Access Compliance Report Public Rights-of-Way (Pedestrian Signals)

Main Street: Location: N/A Intersection ID: N/A Cross Street: N/A

ADA ID: 2ABB69DFBFC7 Signal Type: One Push Button-APS **Overall Compliance: No** Severity Score: BTN 1:N/A BTN 2: N/A No BTN: N/A

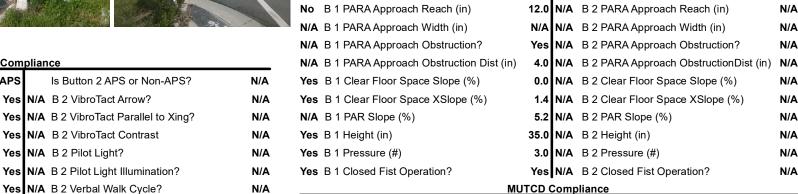
Possible Solutions: Remove & Replace Replace APS Button With New APS Button.

PROW/ADA: R406.2, R404.7.3, R209.1, MUTCD 4e.10
